SERVICE BULLETIN

M-1153

RECALL CODE 0114 - TAILLAMP BULB REPLACEMENT

Figure 1. Taillamp Bulbs And Socket Assemblies

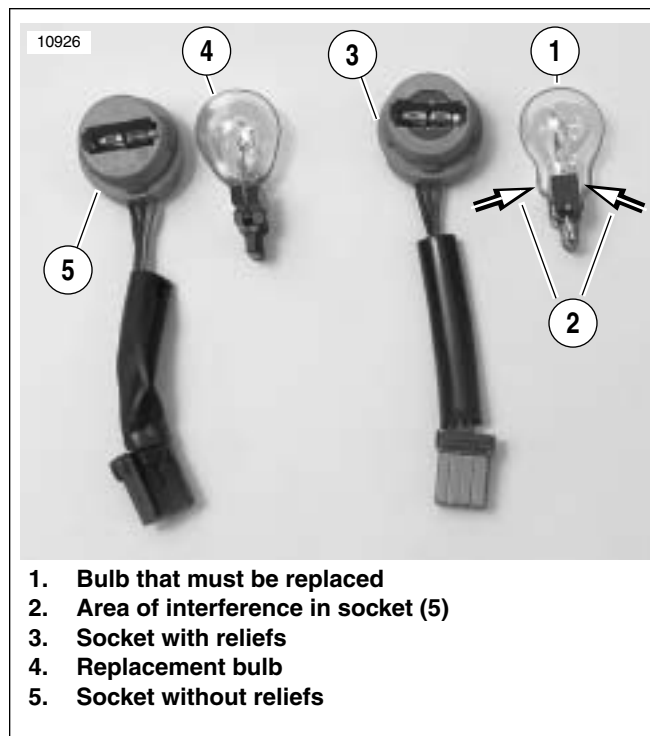
As recently advised in ML-391, Harley-Davidson has identified an issue with the taillamp bulb on certain motorcycles. See Figure 1. The existing taillamp bulb could become loose in the socket and render tail light and brake light inoperative.

See Figure 1. Bulb (1) will only fit socket (3). Bulb (4) will fit both sockets (3) and (5).

In the interest of motor vehicle safety and customer satisfaction, Harley-Davidson has elected to initiate a voluntary recall (Campaign 0114) to replace the taillamp bulb on all affected motorcycles. See REQUIRED DEALER ACTION to perform the recall service.

Figure 3. Taillamp Bulbs

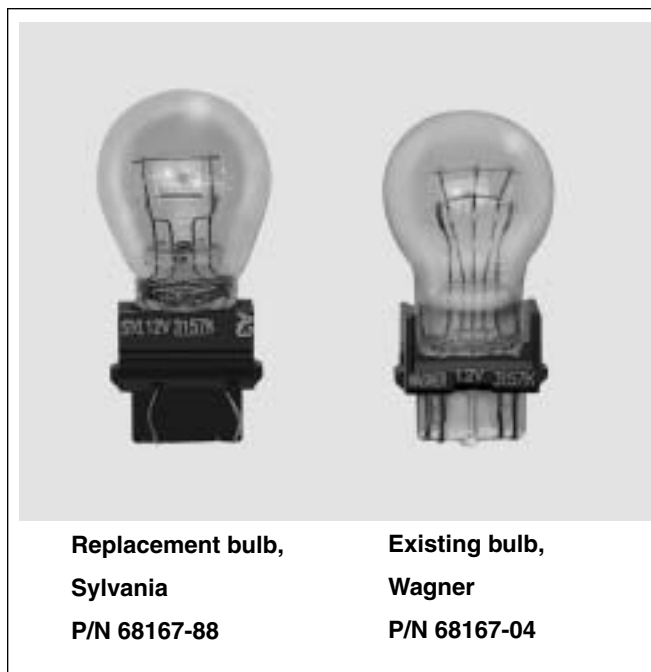
See Figure 3. Both bulbs in Figure 3 were identified as Part No. 68167-88. In January, 2004, the Wagner bulb with the filament support was changed to Part No. 68167-04. Make certain dealer technicians and parts personnel use the correct bulb for future bulb replacements.

See Figure 3. Identify any bulbs in your dealer parts inventory which are the Wagner design and are labelled with the earlier 68167-88 Part No. Relabel these bulbs as Part No. 68167-04 and relocate in an appropriate bin location.
